UNITED STATES
DEPARTMENT OF THE INTERIOR
BUREAU OF LAND MANAGEMENT

FORM APPROVED
OMB No. 1004-0137
Expires: July 31, 2010SUNDRY NOTICES AND REPORTS ON WELLS
Do not use this form for proposals to drill or to re-enter an
abandoned well. Use Form 3160-3 (APD) for such proposals.5. Lease Serial No.
NMNM100569

7. Well Name and No.
MEAN GREEN 27 FED1H

13. Describe Proposed or Completed Operation: Clearly state all pertinent details, including estimated starting date of any proposed work and approximate duration thereof. If the proposal is to deepen directionally or recompleat horizontally, give subsurface locations and measured and true vertical depths of all pertinent markers and zones. Attach the Bond under which the work will be performed or provide the Bond No. on file with BLM/BIA. Required subsequent reports must be filed within 30 days following completion of the involved operations. If the operation results in a multiple completion or recompleat in a new interval, a Form 3160-4 must be filed once testing has been completed. Final Abandonment Notices must be filed only after all requirements, including reclamation, have been completed and the operator has determined that the si

CURRENT WELLBORE

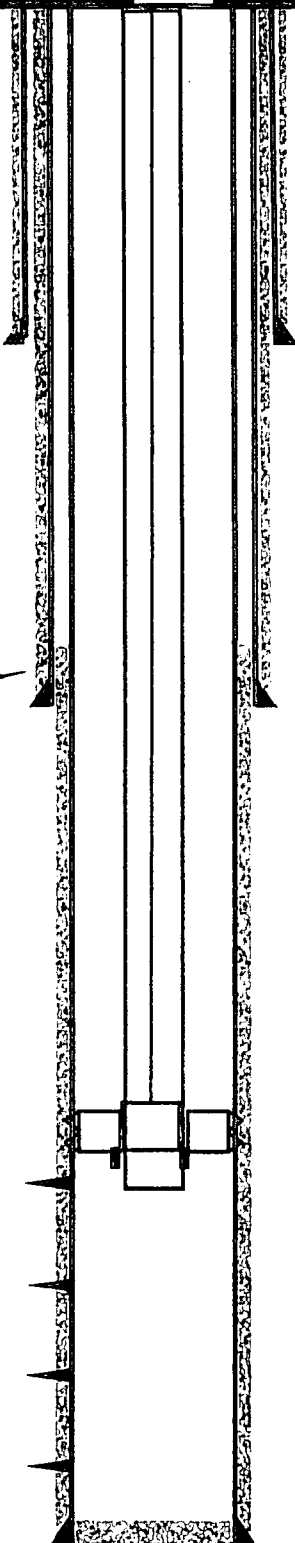
190' plug (8910'), 25 SX spacer from
7800 - 7600.
Add. Perf @ 1425, 502 cm t to
1325. WOC Tag (T/sht).

PROPOSED WELLBORE

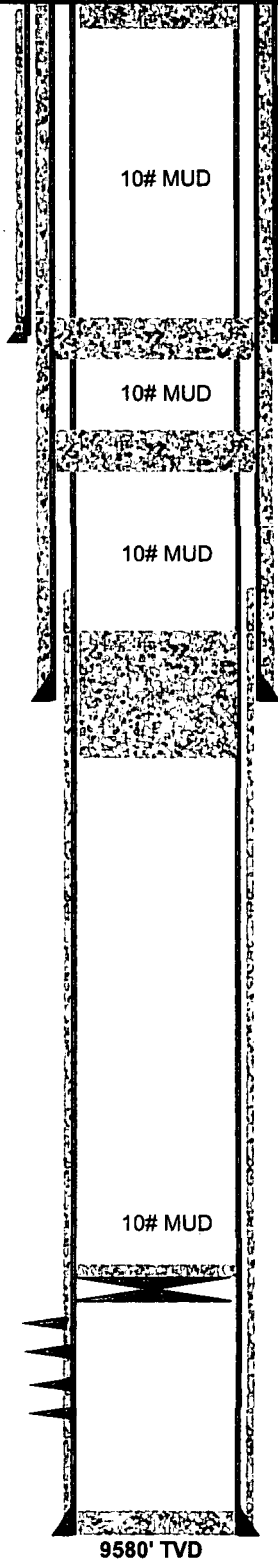
Proposed:

1. Perf @ 140'
2. Pump CI CI from 140'to surface.
3. Cut WH off 3' BGL, Set dry hole marker.

1. Perf at 1000'.
2. Pump 55 sx CI C from 1000-875. WOC & tag.

1. Perf at 2200'.
2. Pump 35 sx CI C 2200-2100'.

1. Spot 40 sx CI C 5400-5200. WOC & tag.
 (T. Delaware 5340', shoe 5320')

1. Set CIBP at 9100'. Tag.
2. Spot 25 sx CI H 9100-9000'.
 (open Delaware perms at 9149')
